Proposal for draft amendments to UN Regulation No. 79 to differentiate the scope of UN Regulation No. 79 and the draft DCAS UN Regulation

Note: The text reproduced below is based on the document GRVA-17-07, further clarifying the intention. It is also proposed to remove references to UN R157 and address all ACSF.

Model A

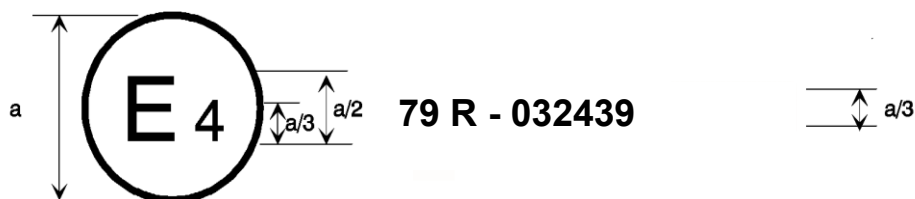
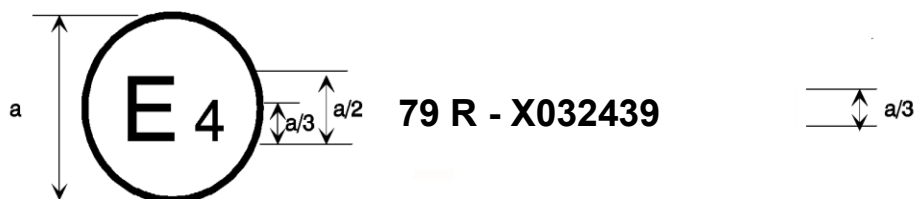
The above approval mark affixed to a vehicle shows that the vehicle type concerned has, with regard to steering equipment, been approved in the Netherlands (E 4) pursuant to UN Regulation No. 79 under approval No. 032439. The approval number indicates that the approval was granted in accordance with the requirements of UN Regulation No. 79 incorporating the 03 series of amendments.

The above approval mark affixed to a vehicle shows that the vehicle type concerned has, with regard to steering equipment, been approved in the Netherlands (E 4) pursuant to UN Regulation No. 79 under approval No. 032439. The letter "X" preceding the approval number indicates that the vehicle is equipped with ACSF or RMF which has been exempted from the requirements of this UN Regulation, and/or that the vehicle is equipped with a steering system which exhibits functionality defined as an ACSF of Category B2, D or E. The approval number indicates that the approval was granted in accordance with the requirements of UN Regulation No. 79 incorporating the 03 series of amendments.

A new marking provision is added so that approvals to Regulation 79 which have made use of the provisions specifically relating to DCAS can be identified, and therefore Contracting Parties who do not apply R[DCAS] can assess whether a Regulation 79 approval is valid in their territory or not.

Model B

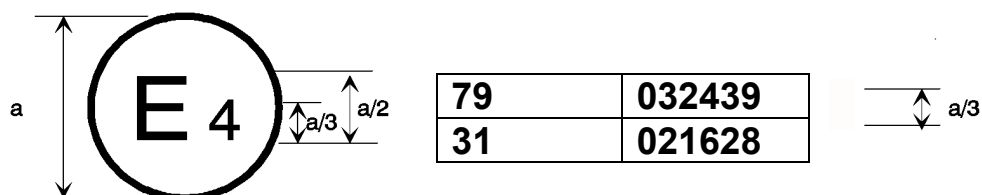
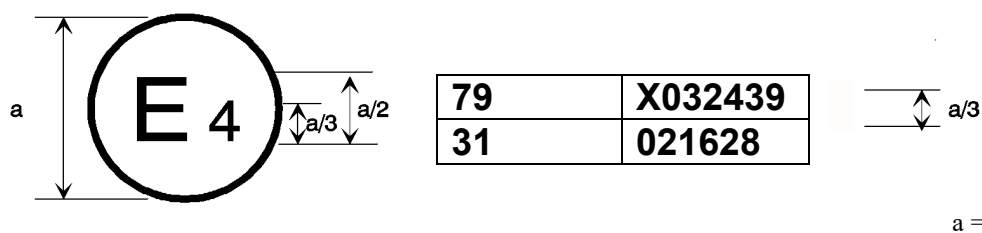
The above approval mark affixed to a vehicle shows that the vehicle type concerned has been approved in the Netherlands (E 4) pursuant to Regulations Nos. 79 and 31.³ The approval numbers indicate that, at the dates when the respective approvals were given, UN Regulation No. 79 incorporating the 03 series of amendments and UN Regulation No. 31 included the 02 series of amendments.

The above approval mark affixed to a vehicle shows that the vehicle type concerned has been approved in the Netherlands (E 4) pursuant to Regulations Nos. 79 and 31.⁴ The letter “X” preceding the approval number pursuant to Regulation No. 79 indicates that the vehicle is equipped with ACSF or RMF which have been exempted from the requirements of this UN Regulation, or that the vehicle is equipped with a steering system which exhibits functionality defined as an ACSF of Category B2, D or E.. The approval numbers indicate that, at the dates when the respective approvals were given, UN Regulation No. 79 incorporating the 03 series of amendments and UN Regulation No. 31 included the 02 series of amendments.
